Amendments to the Drawings:

REMARKS

The Office Action dated November 16, 2004 has been received and reviewed by the applicant. Claims 6-10 are in the application. Claims 6-10 stand rejected. Claim 6 is amended for clarity. Reconsideration is respectfully requested.

FIG. 1c

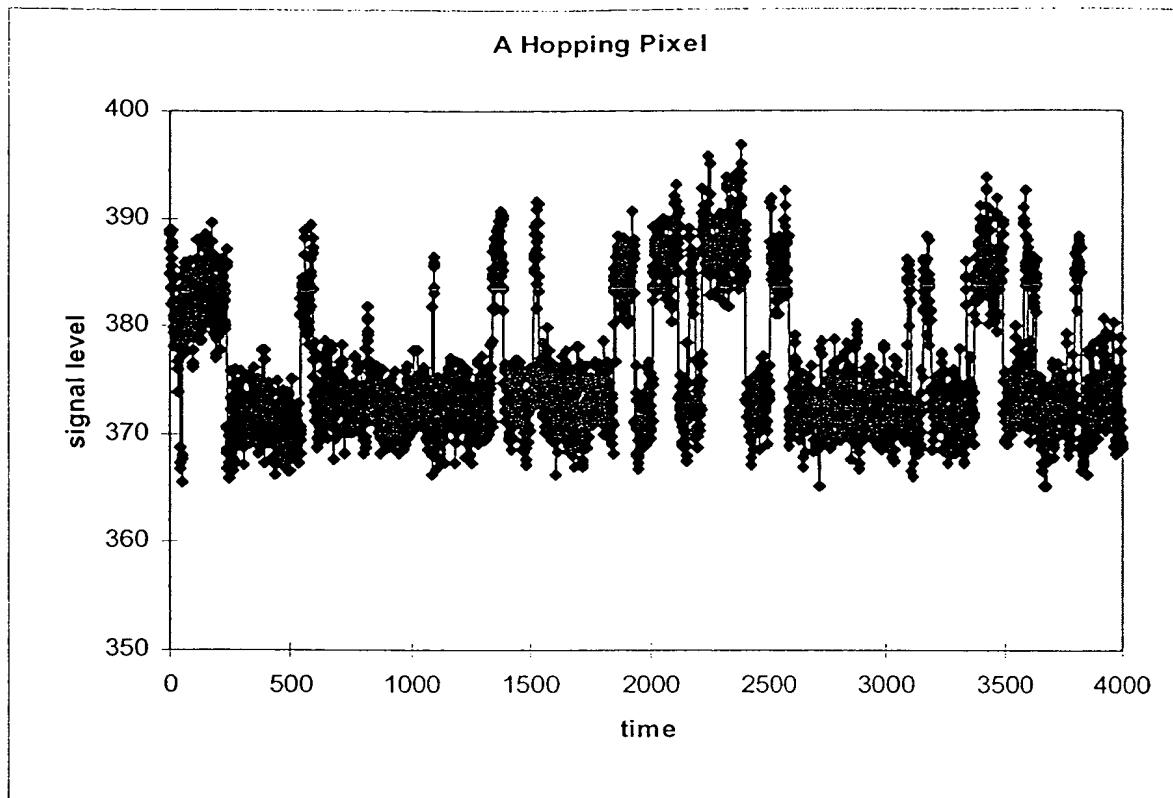
The attached sheet of drawings includes changes to Figs. 1c and 1d. Approval by the Examiner is respectfully requested. Once the Examiner's approval is received, a complete set of formal drawings will be submitted by Letter of the Draftsperson.

The Examiner is thanked for the approval of Figures 1a and 1b. The objection to Figures 1c and 1d is maintained. Figures 1c and 1d should be designated by a legend such as --Prior Art-- because only that which is old is illustrated. In this regard, a proposed drawing change is included herewith for the Examiner's approval.

Prior Art
